ADDENDUM #3

Re: Harrisburg Area Community College
York Campus
Renovations for the Student Government Association – Goodling Building Room 21
Solicitation #RFB13-01

3.1 CHANGES TO THE DRAWINGS

DWG. NO. SK-1
DATE: 7/10/2012

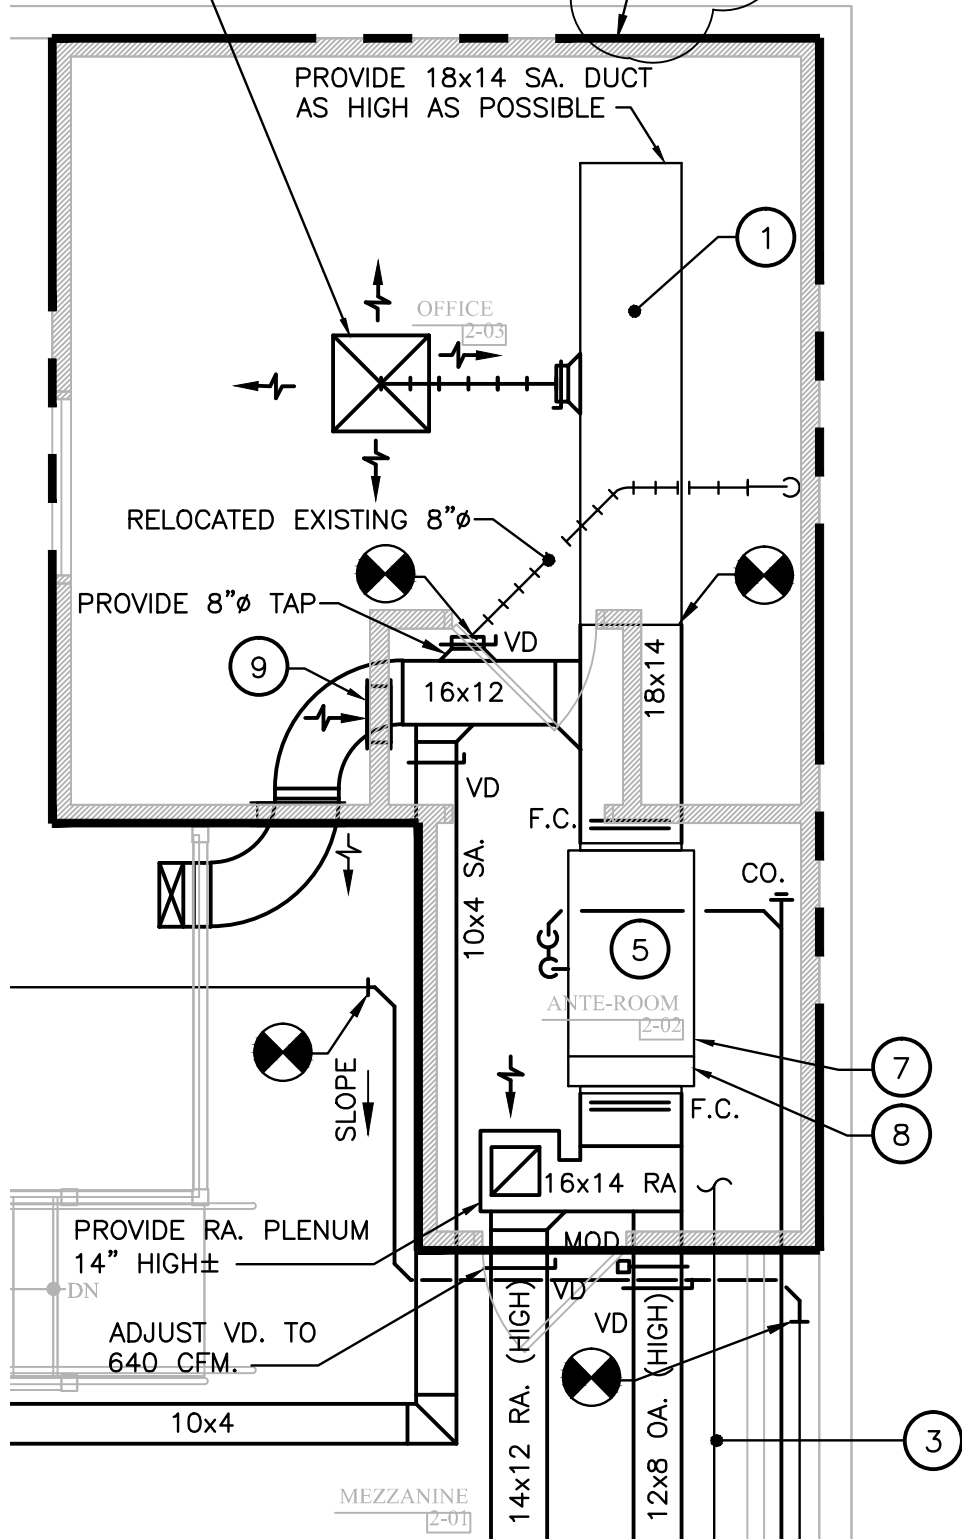
PLUG EXISTING FLOOR DRAIN

CONTRACTOR SHALL EXTEND EXISTING FIRE SPRINKLER PIPING DOWN TO LOWER OFFICE AREA AND PROVIDE COMPLETE DESIGN AND INSTALLATION OF FIRE SPRINKLER COVERAGE IN THIS AREA. (APPROX. 270 SQ.F.T.)

CONTRACTOR SHALL ADJUST LOCATION AS REQUIRED TO FIT INTO GRID
PROVIDE UNDER CUT ON DOOR

PROVIDE 16x6 DUCT DN.

PROVIDE 9x9 NECK, 12x12 LOUVER FACE SUPPLY DIFFUSER WITH DROP BEVEL FRAME ADJ. THROW SUCH AS TITUS TDCA WITH OFF -WHITE FINISH AND 3-WAY BLOW PATTERN ADJUST TO 95 CFM

PROVIDE 16x6 DUCT ABOVE CEILING ROUTE AS REQUIRED TO MISS EXISTING AND/OR NEW LIGHTING AND TO WORK WITH STRUCTURE

PROVIDE UNDER CUT ON DOOR

RELOCATED H.P. THERMOSTAT TO THIS LOCATION AT 60" A.F.F.± OR PER ADA REQUIREMENTS

CONTRACTOR SHALL EXTEND EXISTING FIRE SPRINKLER PIPING DOWN TO LOWER OFFICE AREA AND PROVIDE COMPLETE DESIGN AND INSTALLATION OF FIRE SPRINKLER COVERAGE IN THIS AREA. (APPROX. 490 SQ.F.T.)
